Prolific Technology Inc.			
Title	PL1061D-QFP		
Size	Document Number	Rev	
B	PL1061D	A	
Date:	Tuesday, July 15, 2008	Sheet	3 of 9

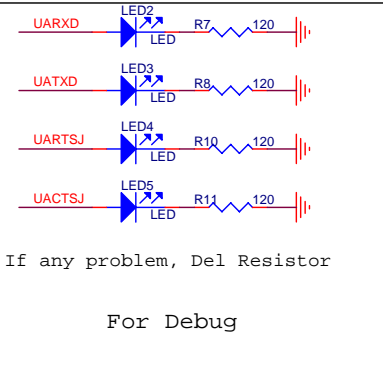
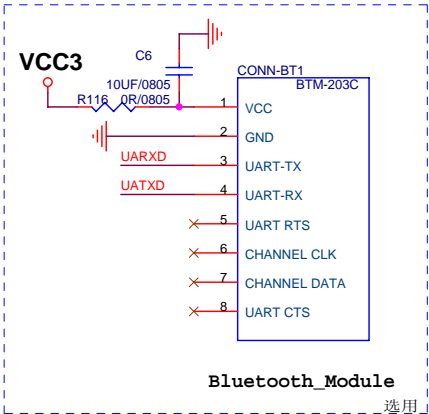
Add 1013/06

U4-Pin30:Connected to J3 and U13
U4-Pin31:Connected to R137

WIO0 Pull-down for H/W trapping

Add 1103/06

Add 1103/06
Delete S1 , R9

If any problem, Del Resistor
For Debug

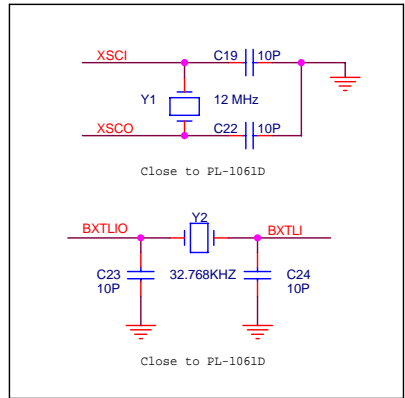
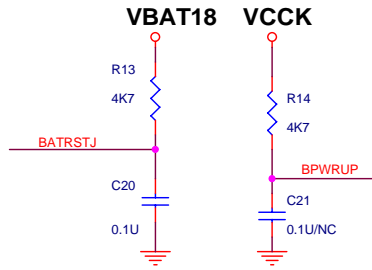
Add 1103/06
Delete R23, R24
